UNITED STATES
NUCLEAR REGULATORY COMMISSION
WASHINGTON, D.C. 20555-0001

LICENSEE: PSEG Nuclear, LLC
FACILITY: Hope Creek Generating Station
SUBJECT: SUMMARY OF TELEPHONE CONFERENCE CALL HELD ON
JUNE 21, 2010, BETWEEN THE U.S. NUCLEAR REGULATORY COMMISSION
AND PSEG NUCLEAR, LLC, CONCERNING REPOSSES TO REQUESTS FOR
ADDITIONAL INFORMATION PERTAINING TO THE HOPE CREEK
GENERATING STATION LICENSE RENEWAL APPLICATION

MEETING ON RESPONSE TO NRC REQUESTS FOR ADDITIONAL INFORMATION
FOR HOPE CREEK GENERATING STATION LICENSE RENEWAL APPLICATION

FIG. 1 - REACTOR BUILDING AND PRIMARY CONTAINMENT CROSS SECTION DURING FULL SCALE CUTTING.

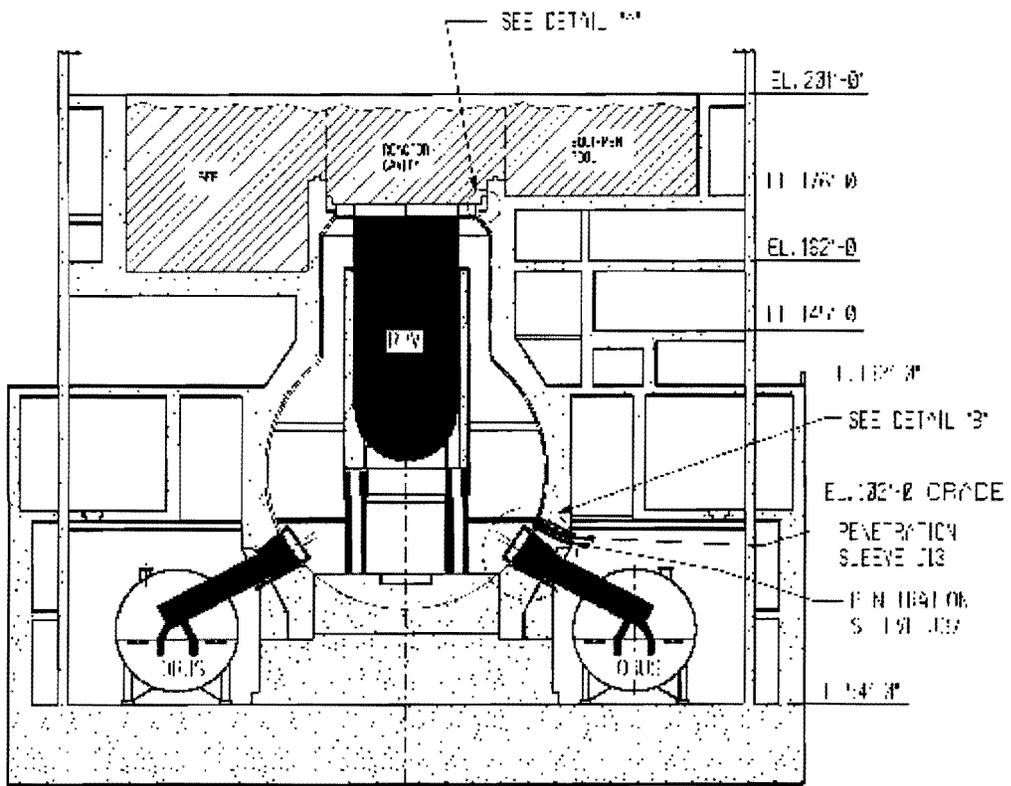
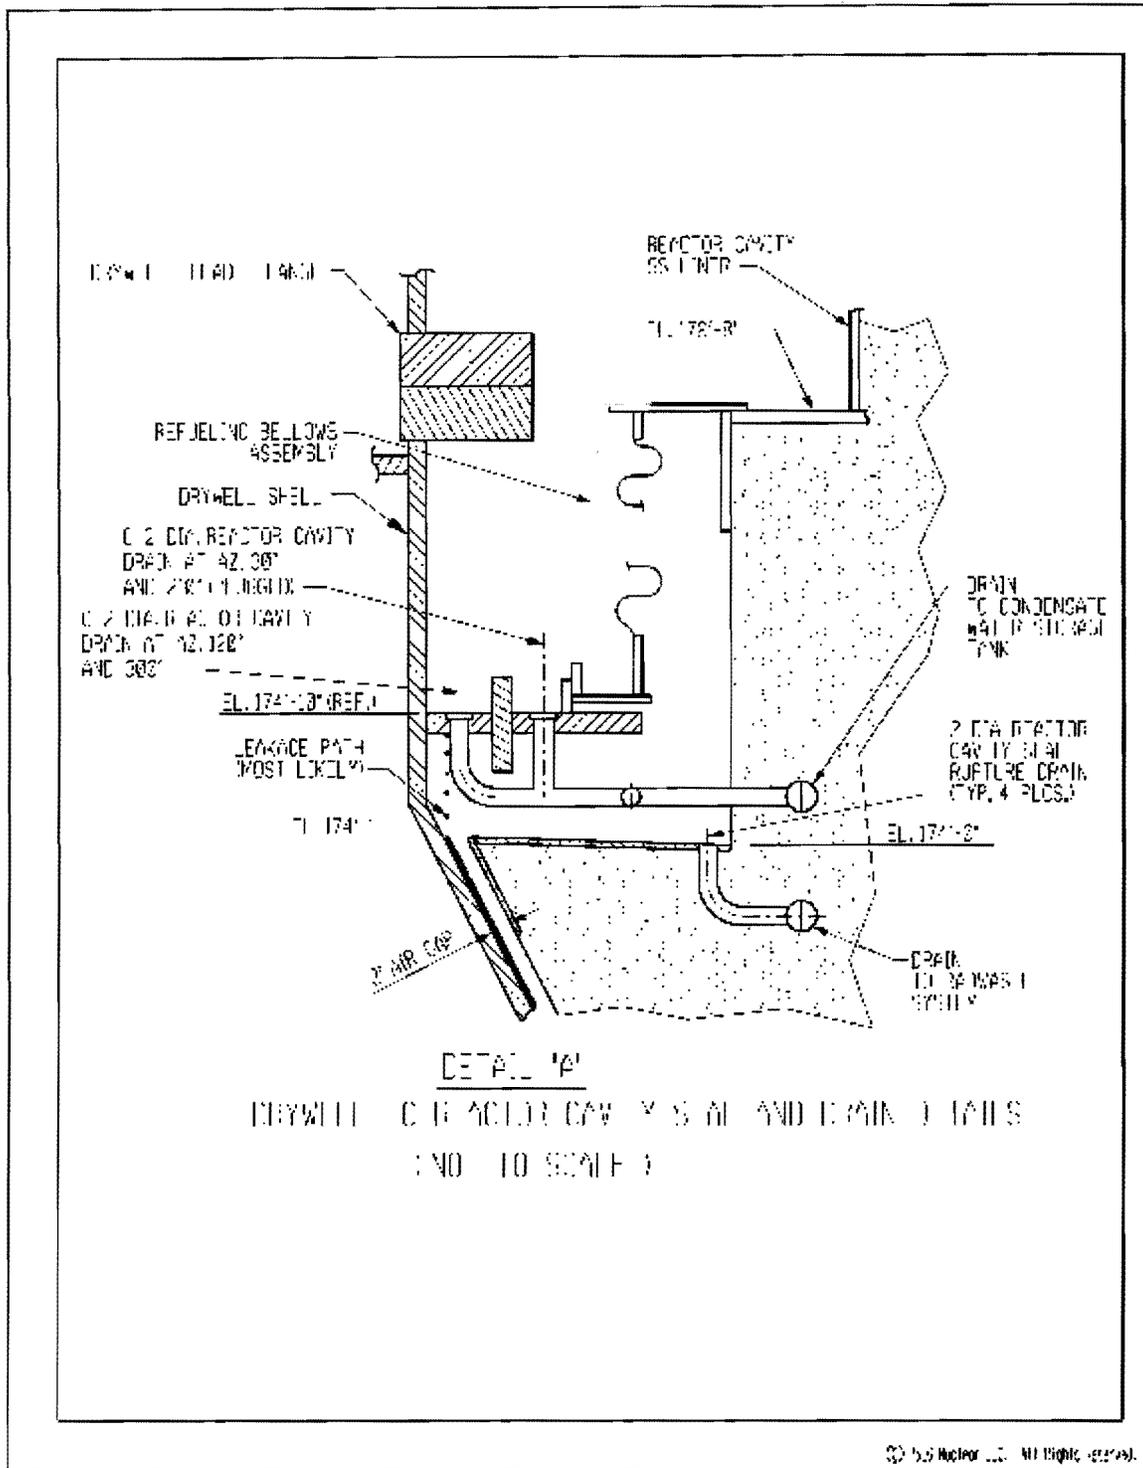
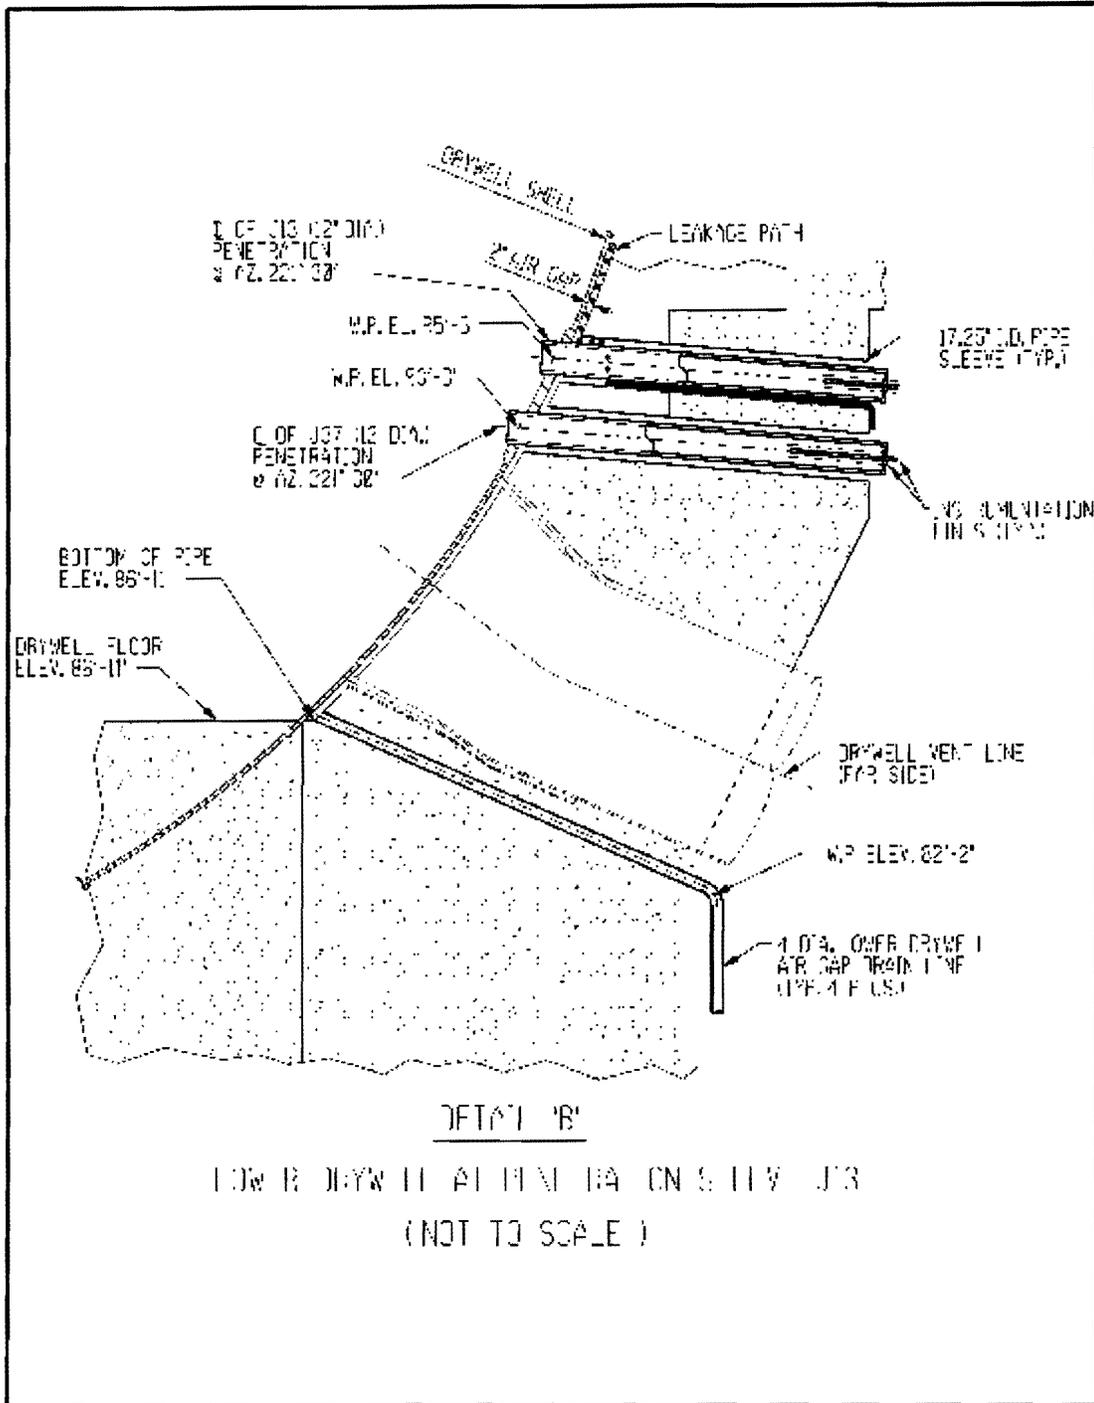
Also, please provide a drawing of the drywell area which shows different components for reference. This will help us understand the leakage flow path and will enable us to communicate better.

1. Thickness and corrosion allowance of the drywell (both thicker and thinner plate sections)
2. The email from John Hufnagel states that penetration J37 is approximately 7 inches directly below J13. However, the attached sketch shows that J13 is located 2 feet above J37. This sketch was previously provided b

PSEG provided the three drawing that are shown in Attachment 3.

1. The thickness of the drywell shell in the region of the J13 penetration is 1.5 inches thick as noted on LRA Page 3.5- 24 for the Lower Sphere Location. The local thickness used at the reinforcing area at the penetrations is 3.0 inches. The corrosion allowance is .063 inches.
2. The centerline distance between penetrations J13 and J37 is 24 inches. The penetration nozzles are 12.75 in outside diameter, therefore distance between the edges of the nozzle is approximately 11 inches and not 7 inches as stated.
